**TOWN OF MOUNTAIN VILLAGE
REGULAR DESIGN REVIEW BOARD MEETING
THURSDAY AUGUST 1, 2019 10:00 AM
2nd FLOOR CONFERENCE ROOM, MOUNTAIN VILLAGE TOWN HALL
455 MOUNTAIN VILLAGE BLVD, MOUNTAIN VILLAGE, COLORADO
REVISED AGENDA**

3.	10:05	45	Miller	Public Hearing Quasi-Judicial	Consideration of a Design Review: Initial Architecture and Site Review Application for a new single-family residence on Lot 640BR 1, Timberview (continued from July 11, 2019)

4.	10:50	45	Miller	Public Hearing Quasi-Judicial	Consideration of a Design Review: Initial Architecture and Site Review Application for a new single-family residence on Lot 640BR-4, Timberview

UTILITY PLAN/GRADING PLAN
SCALE: 1" = 5'

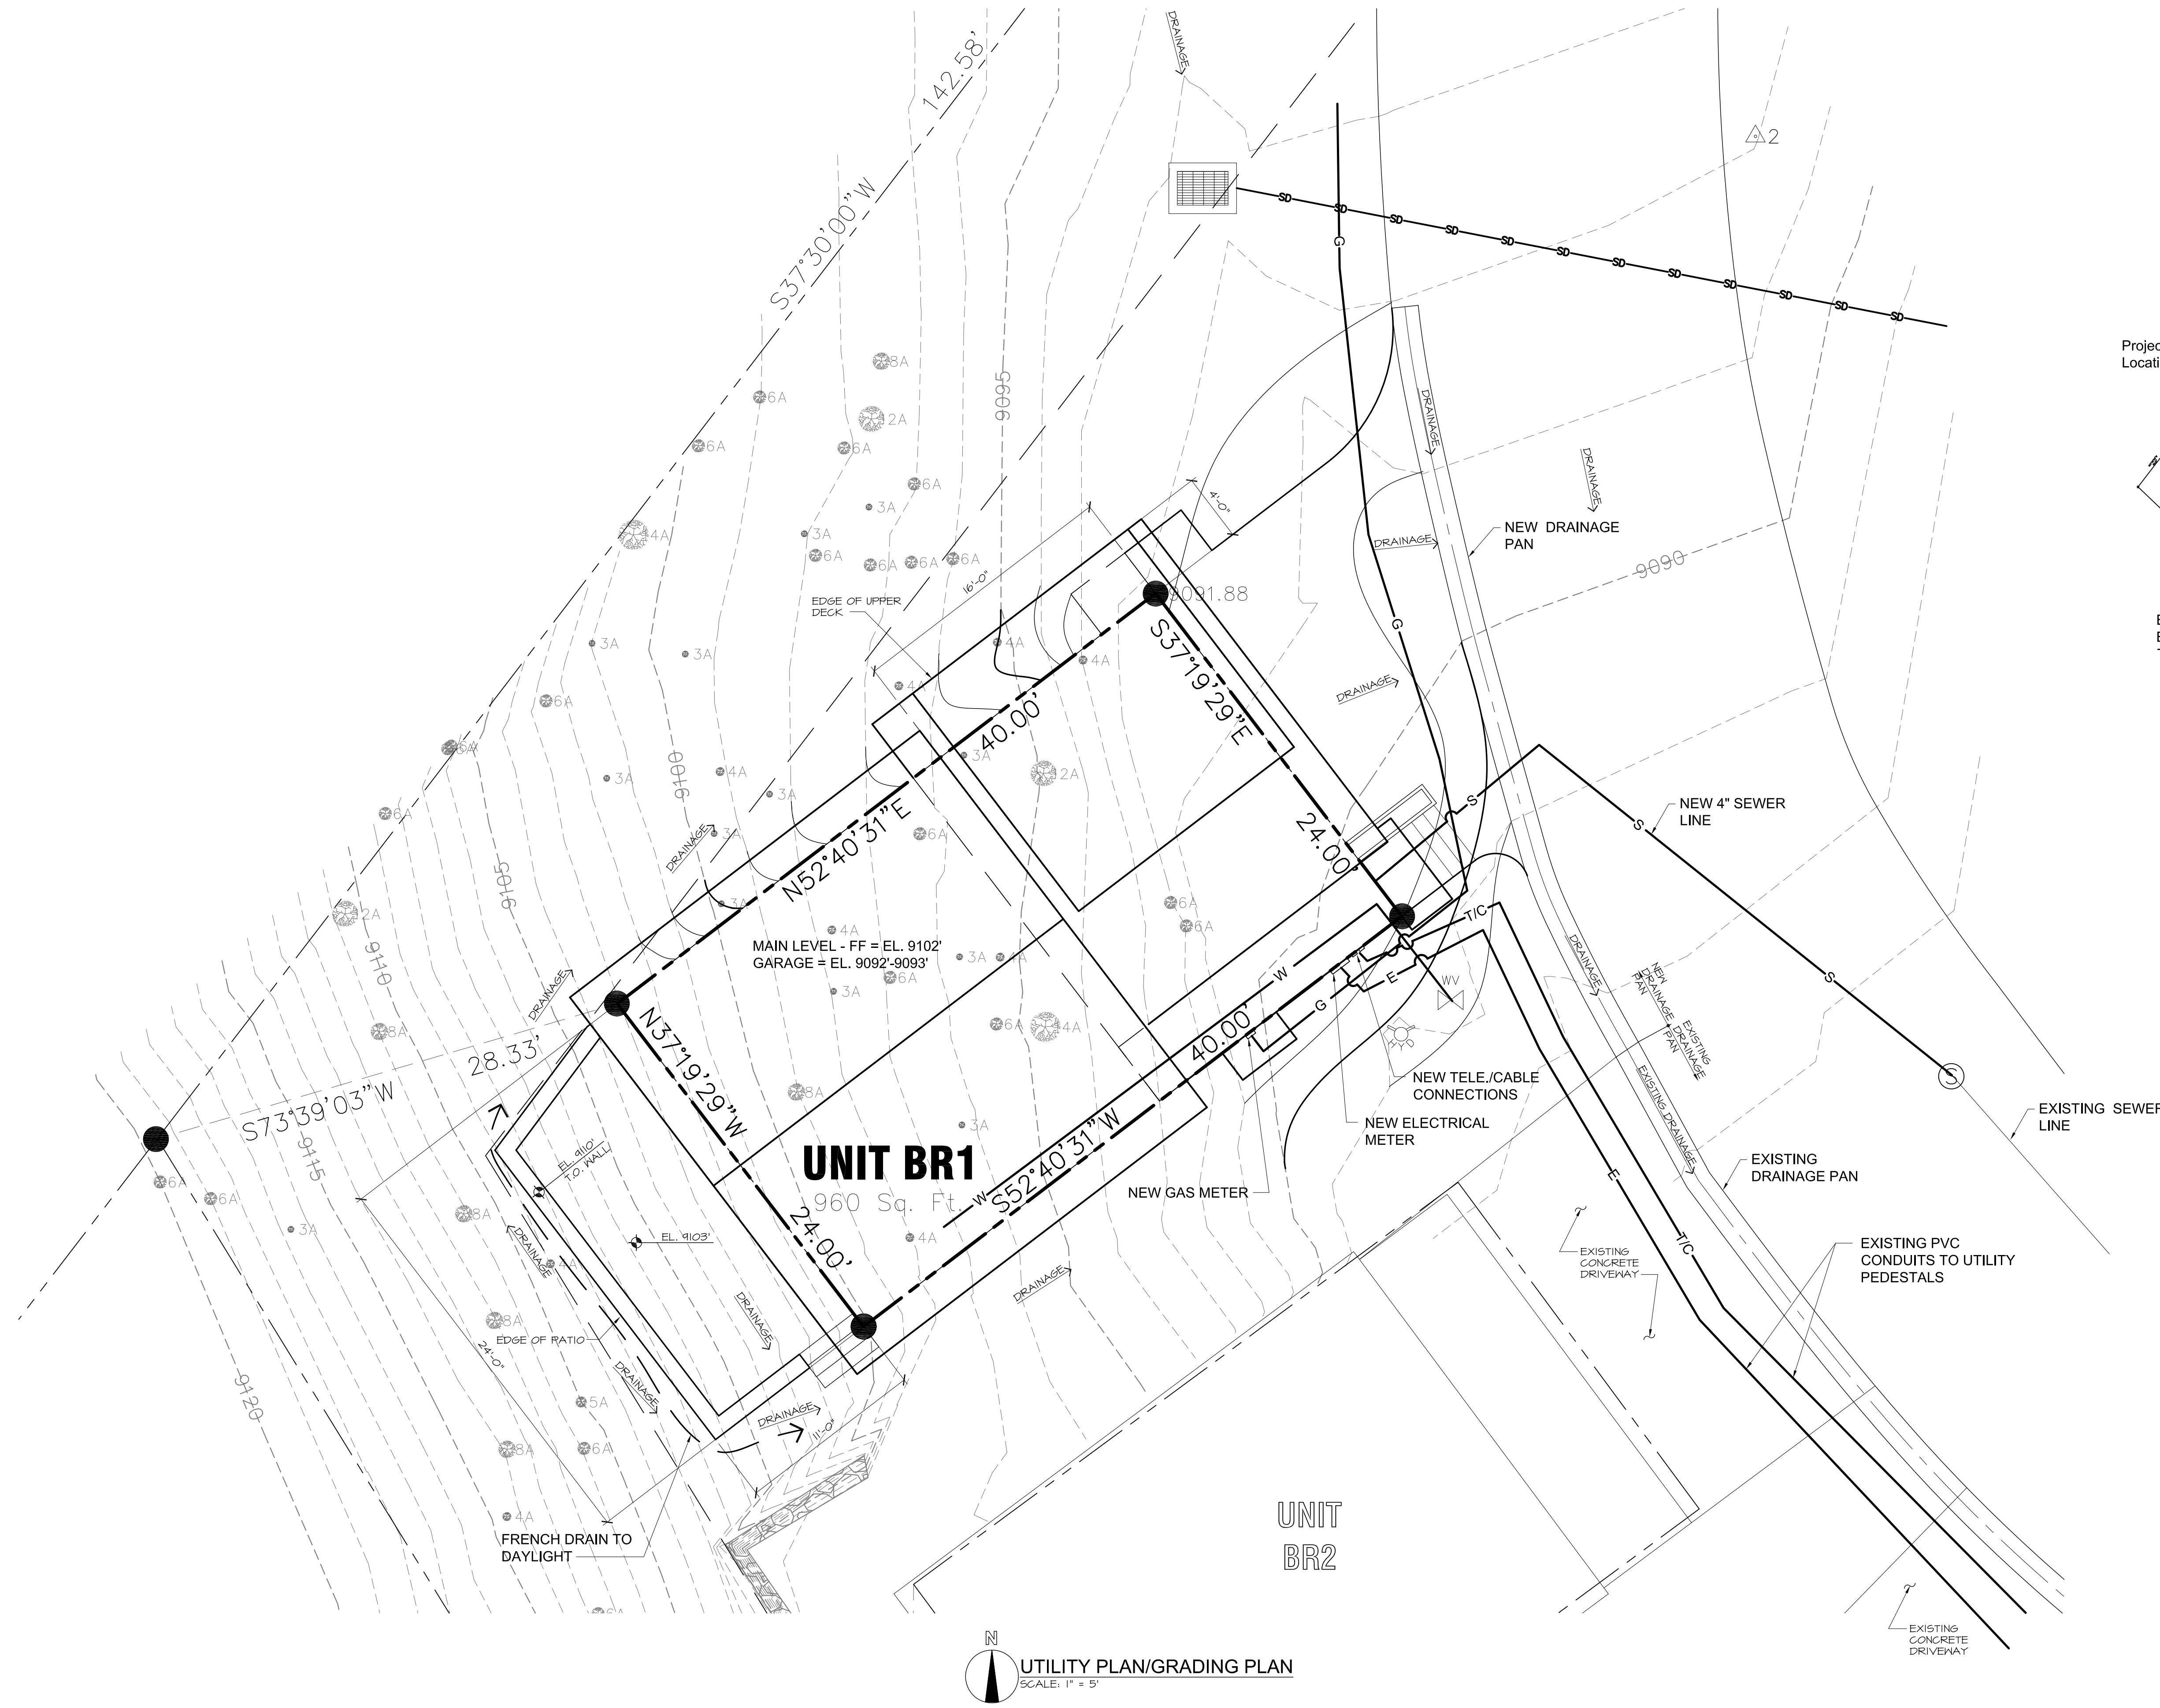
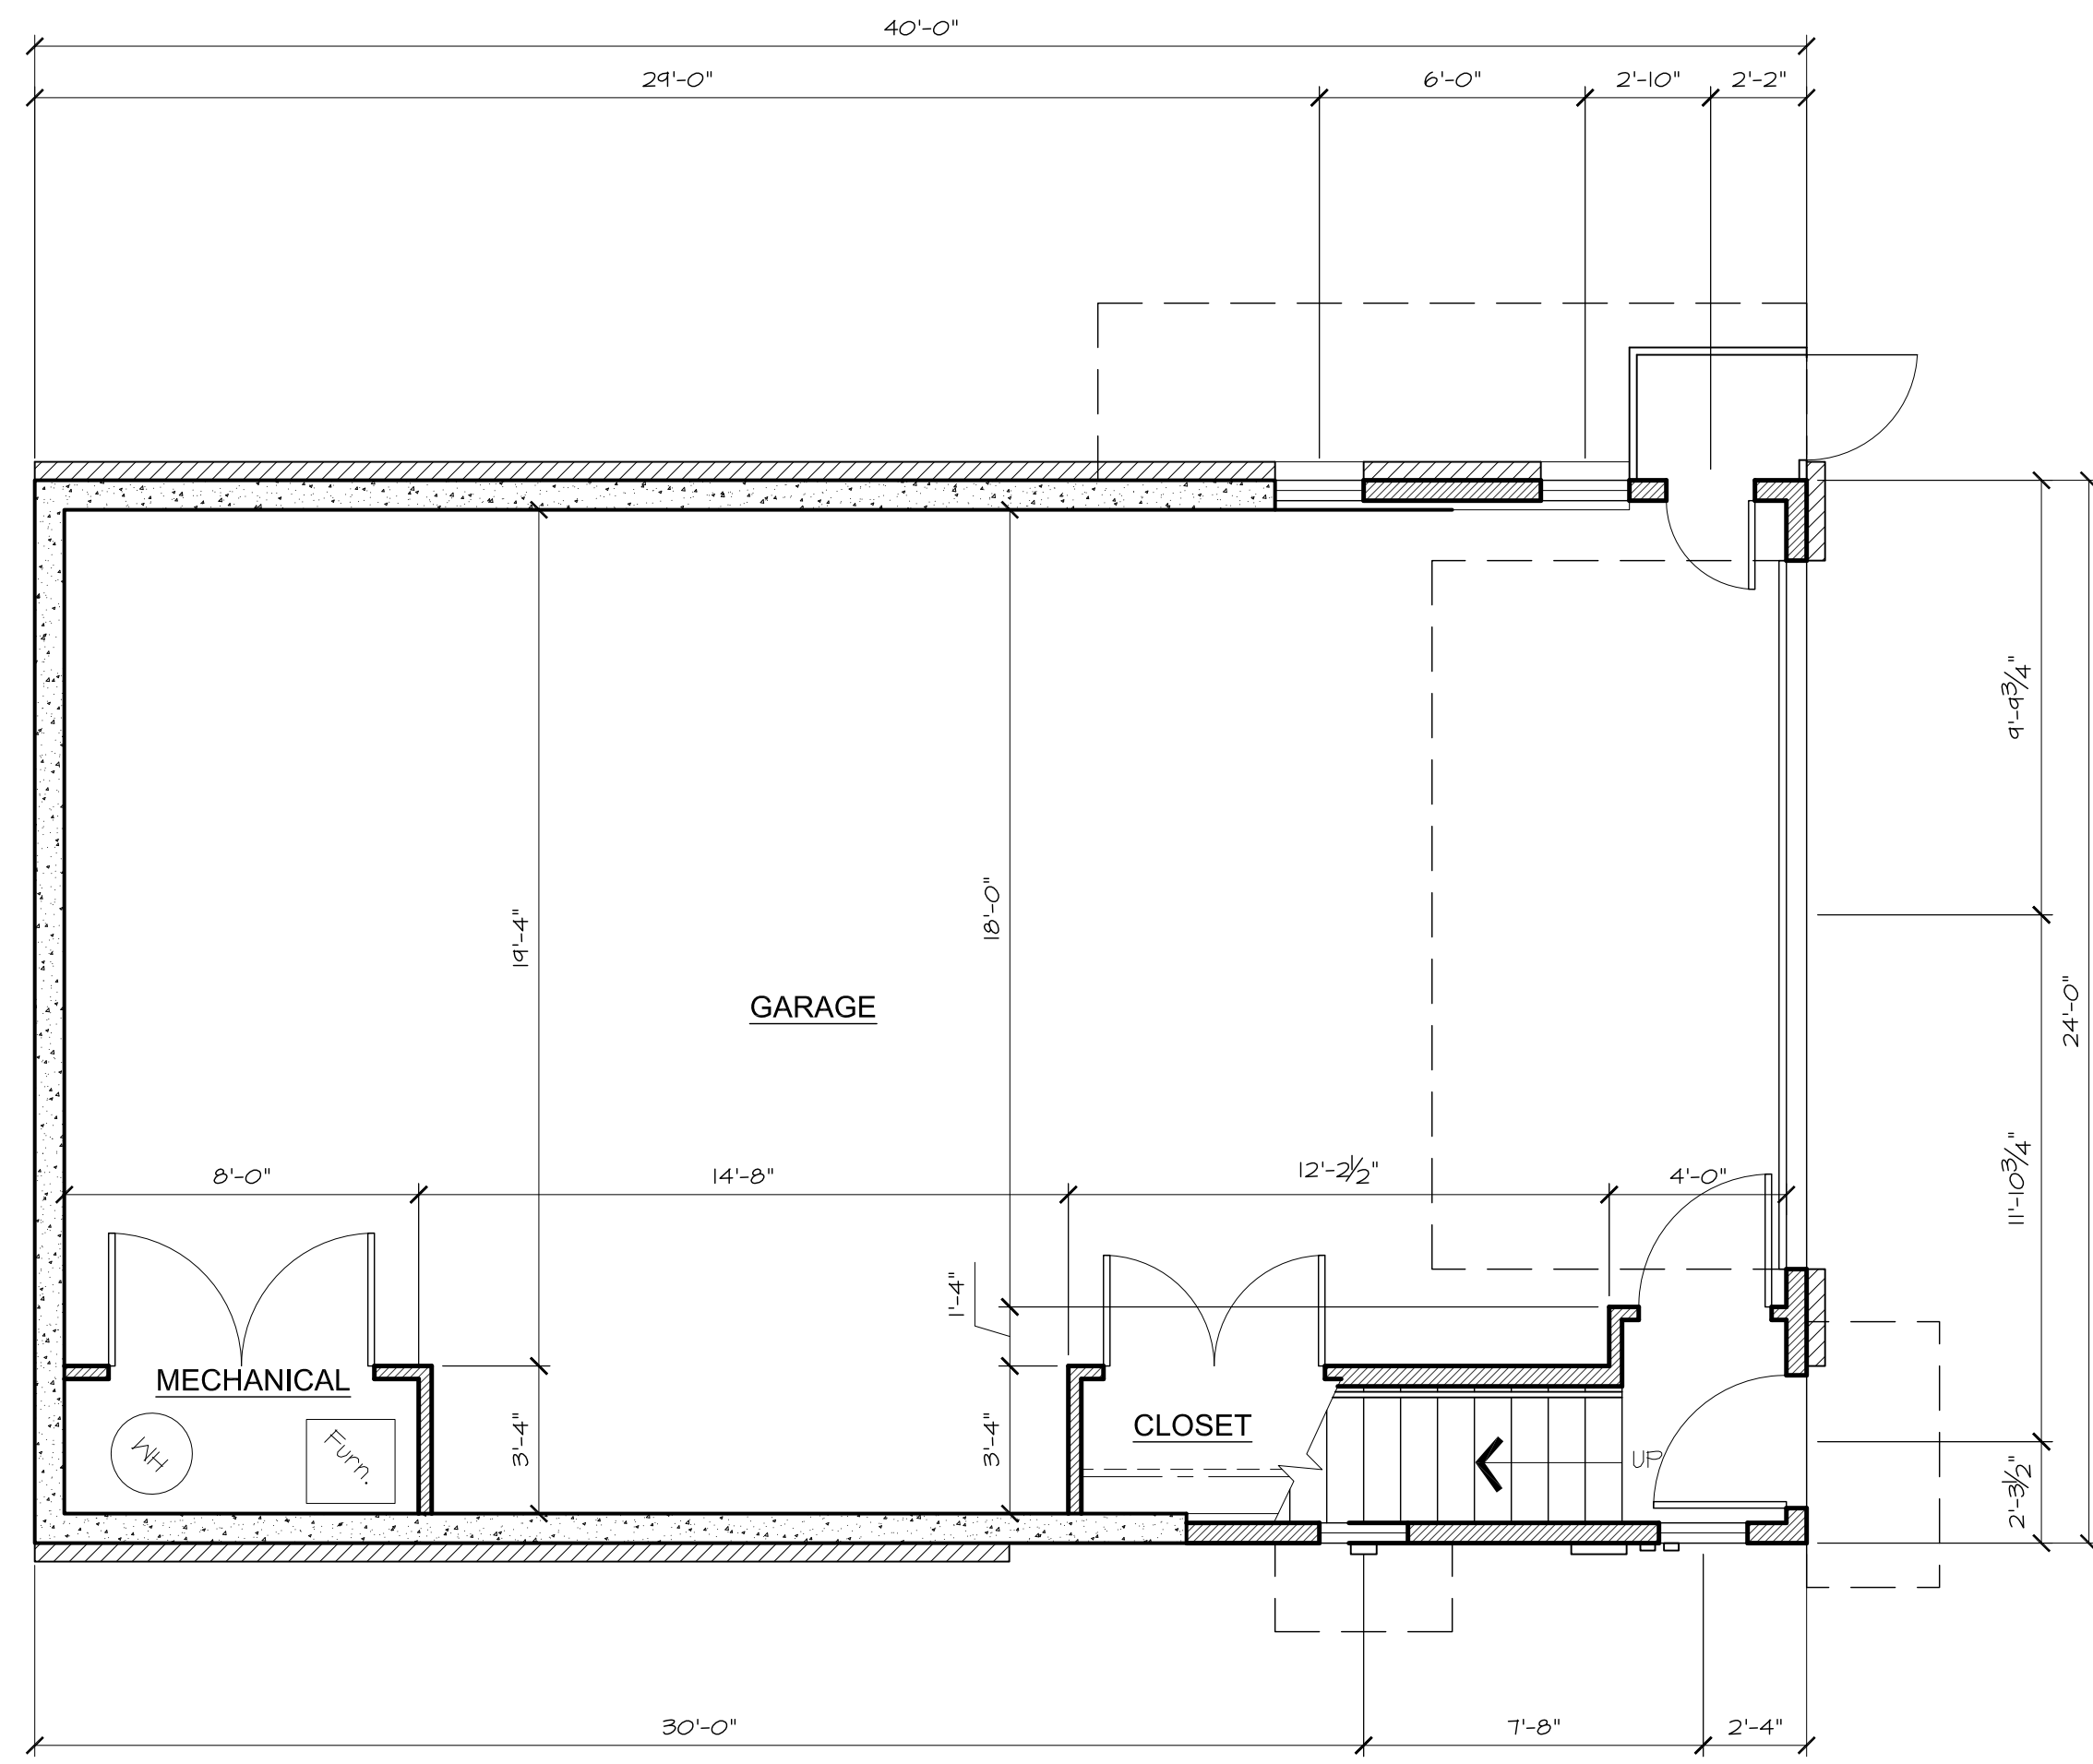
Staff: The applicant has not provided a grading and drainage plan at this time. Prior to final architecture and site review, a full grading and drainage plan shall be submitted which shall document all disturbed areas, cuts, fill, final slopes adjacent to the home, stormwater design including positive drainage from proposed home, and specifications of any retaining walls that are necessary to construct the home.

Staff: All utilities are currently located within 640BR-1 and will not require any additional extensions within Town ROW or property. The plan set shows the proposed connection location for the project's utilities to the east of the home.

- 2) The applicant shall be required to submit an updated and finalized grading and erosion control plan detailing any retaining walls, proposed grading, stormwater mitigation techniques, material storage calculations, etc. This plan shall demonstrate how final grades adjacent to the home meet the requirements of the CDC.

- 5) Prior to the issuance of a building permit, the applicant shall field verify all utilities and submit a revised utility plan to the public works director identifying the location of utilities and connection points.
